AMENDMENT OF SOLICITATION/MODIFICATION OF CONTRACT

National Aeronautics and Space Administration
NASA Glenn Research Center
Cleveland, Ohio 44135

Potential Offerors: Cooling Tower Rehab Solicitation

9A. AMENDMENT OF SOLICITATION NO.
NNC12ZFD011E

CC 179205

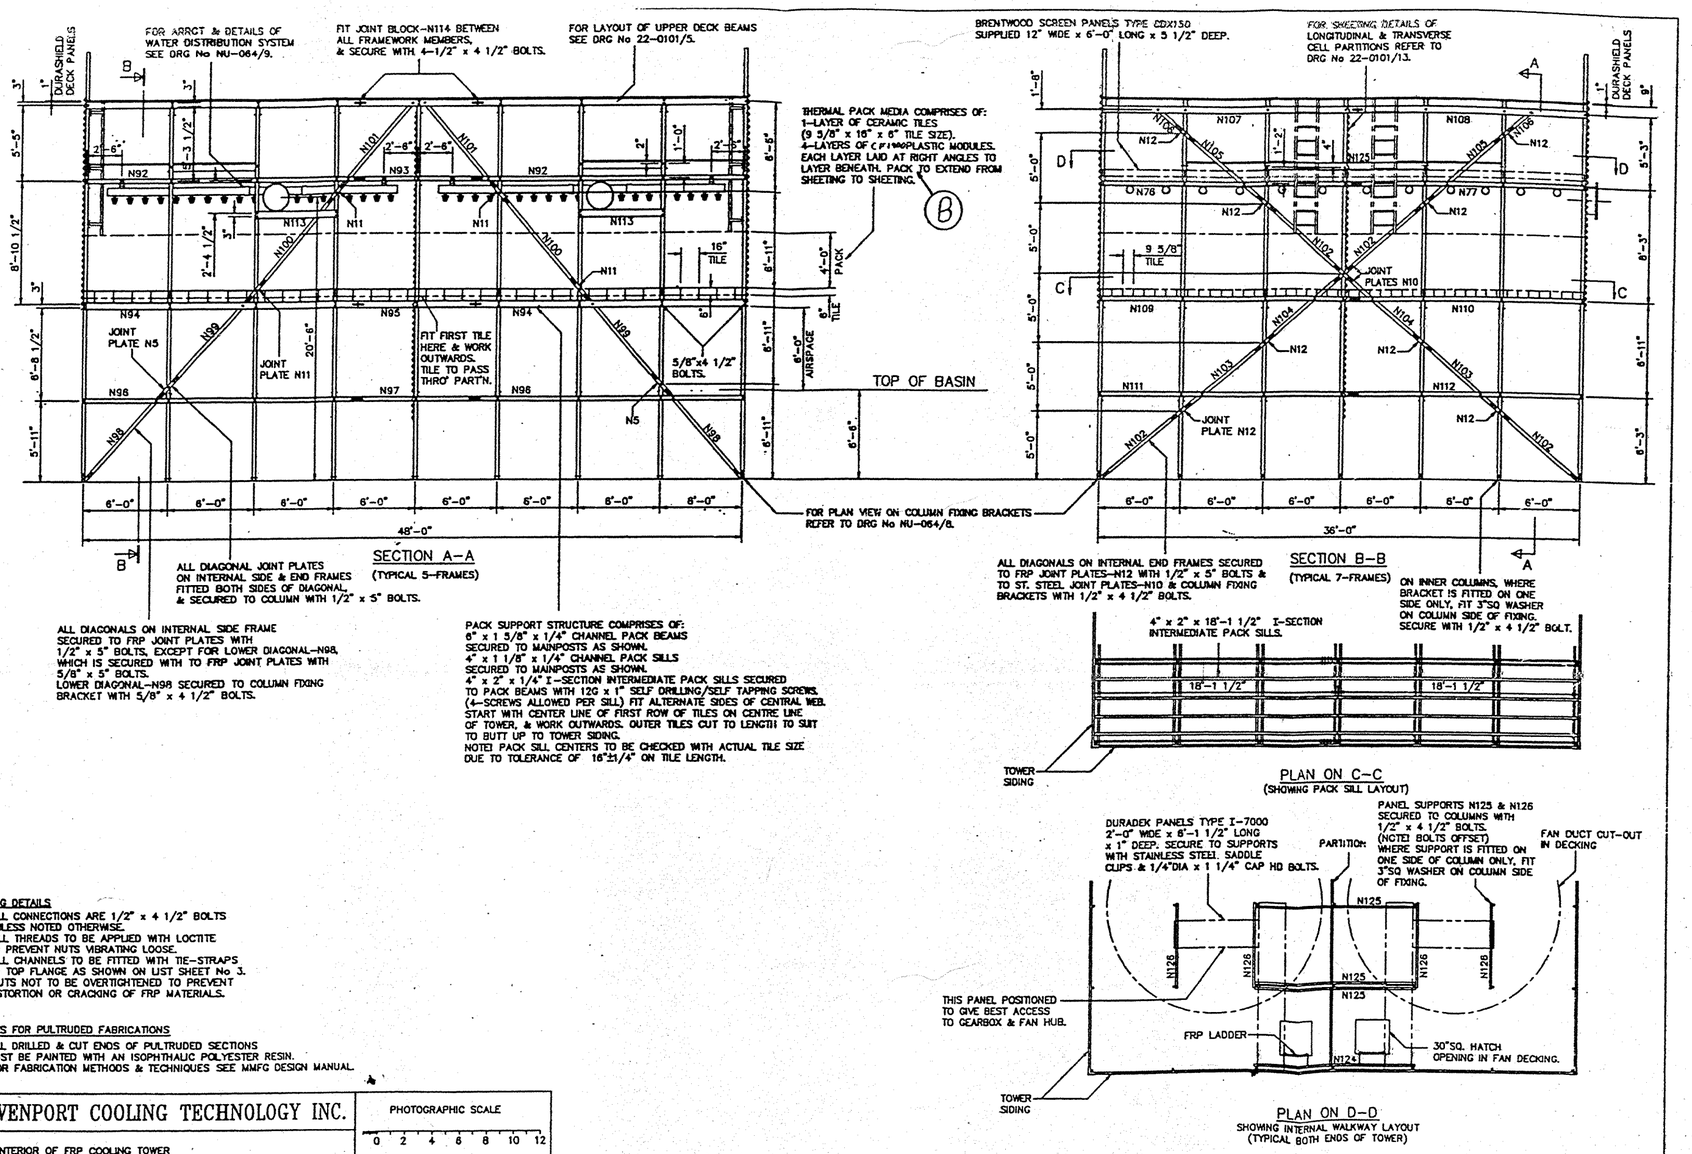
15. Cooling Tower #4 Handrail
It is in the scope of work to remove, rehabilitate and reinstall the FRP handrails on Cooling Tower #4. It is assumed that these handrail posts spliced into the structural columns. The exterior casing is assumed to be attached to the structural columns and handrail posts. When removing handrail posts for rehabilitation it will require casing to be removed, which will cause damage to the casing. Please provide the splice location between the structural column and handrail posts in order to quantify how much casing to replace.

REPLY:
Rehabilitate and reinstall the FRP handrails, the posts shall remain in place.

See existing reference drawings (CC-179205, CC-179208) of the original construction.

CF 182151
STRUCTURAL
OFFICIAL DATE 5/13/88

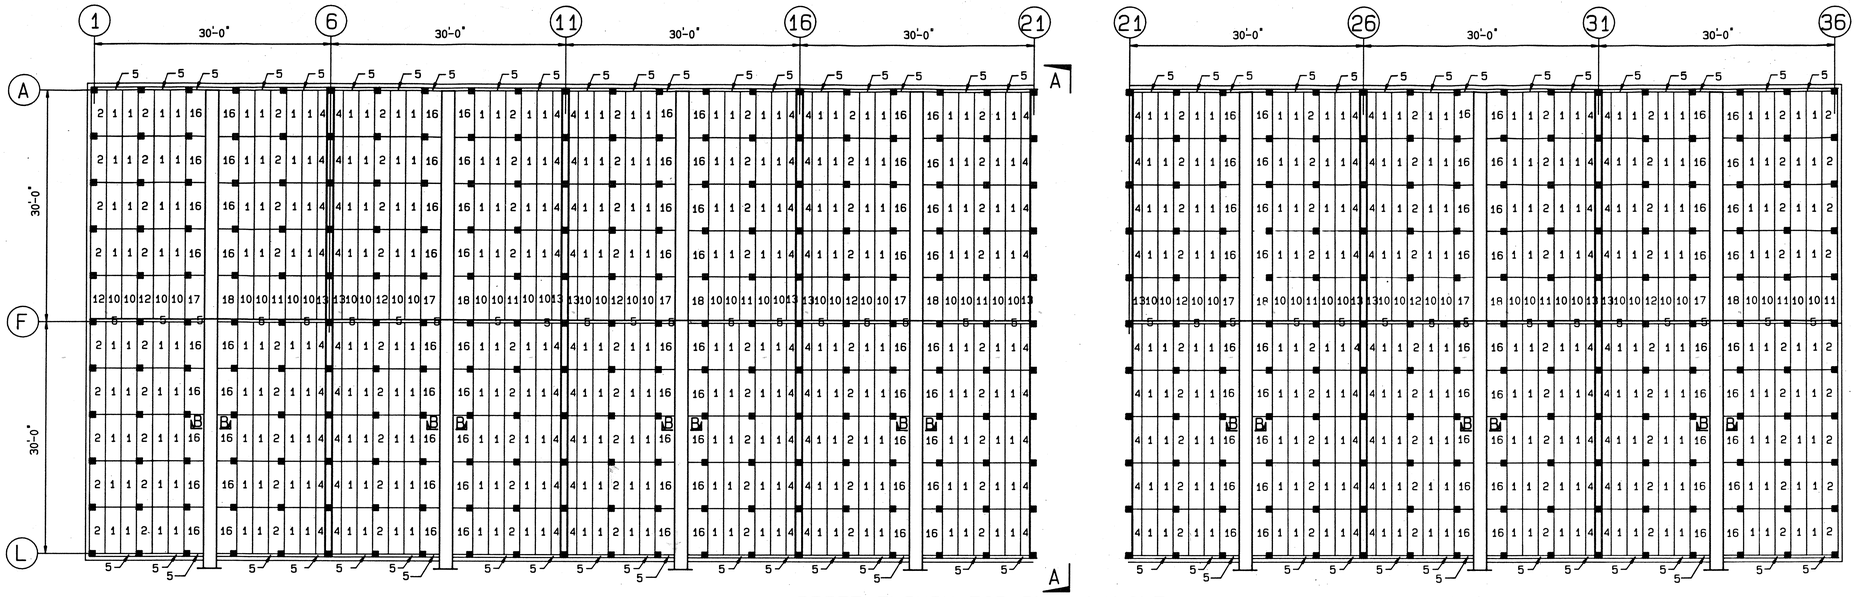
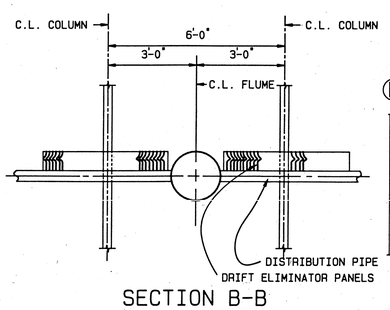
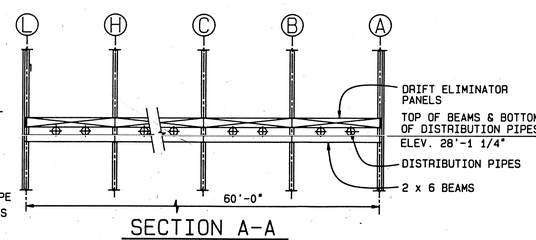
16. Drift Eliminator Supports
In specification section 23 65 00 subpart 2.5.2 it states that "Tee sections shall be suspended with ¼ inch brass rods connected to stainless steel clips embedded in the bottom side of the roof deck at the time of casting. Eliminators may be supported by brass or stainless steel suspension rods from the fan deck or supported directly on concrete beams." Please advise if this is in the scope of work for drift eliminator replacement and is so please provide detail.

REPLY:
The drift eliminators shall be installed on the existing supports.
Supports that are damaged shall be replaced.

See the reference drawings CE-191113 (CT 3) and CF-182151 (CT 5) as examples of existing drift eliminator installation.

CF 182154
STRUCTURAL
OFFICIAL DATE 5/13/88

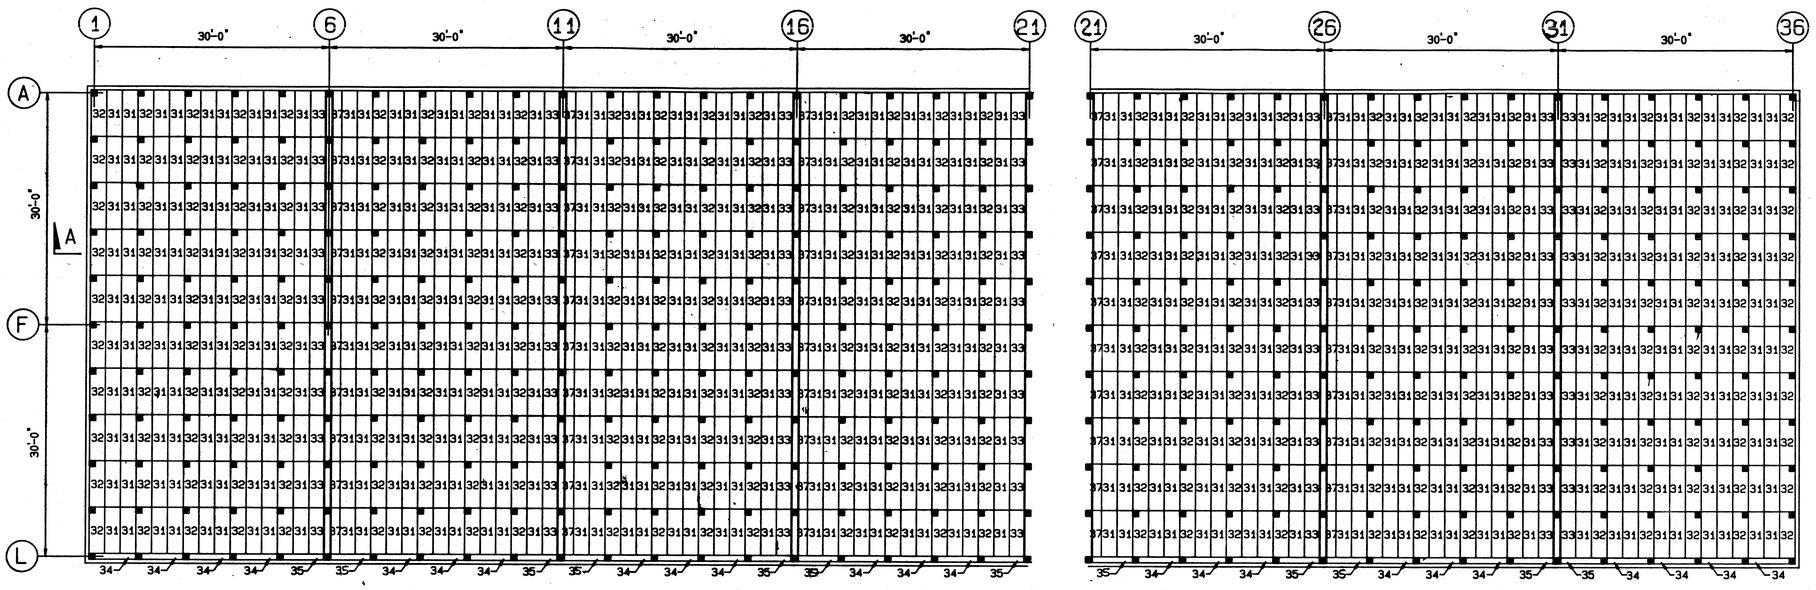
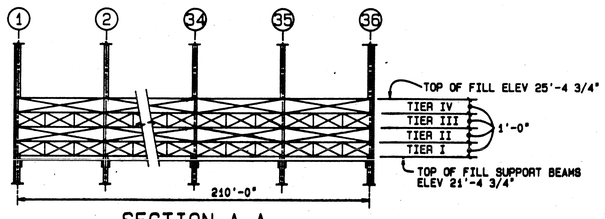
12. Fill Depth
It is unclear the fill quantities that are being asked to replace. Per drawing C-101 Section A-A for cooling tower #1 it shows for a 2 feet fill depth. However, the quantities listed on drawing C-101: Note 6, state that for 6 cells (24'-2-3/4" X 45'-1") that (540) pieces of 10 mil, CF 1900MA and (1080) pieces of 15 mil, CF 1900MA are required. Each piece of fill is 24" x 24" x 72", which has a square footage of 12 sf. The square footage for each cell is 1080 sf. The equation below states how this calculates.

Based upon the quantities provided in C-101: Note 6, there is a discrepancy between that and the 2' fill depth per Section A-A drawing C-101. Please advise what the correct fill depth is being asked to replace. This applies to all other cooling towers that are requesting new fill material.

REPLY:
The fill depth shall be full replacement which is 6'-0" feet, except for Cooling Tower No. 5, which is 4'-0".

See reference drawings CE-191121 (CT 3) and CF-182154 (CT5) as examples of existing fill media installation.
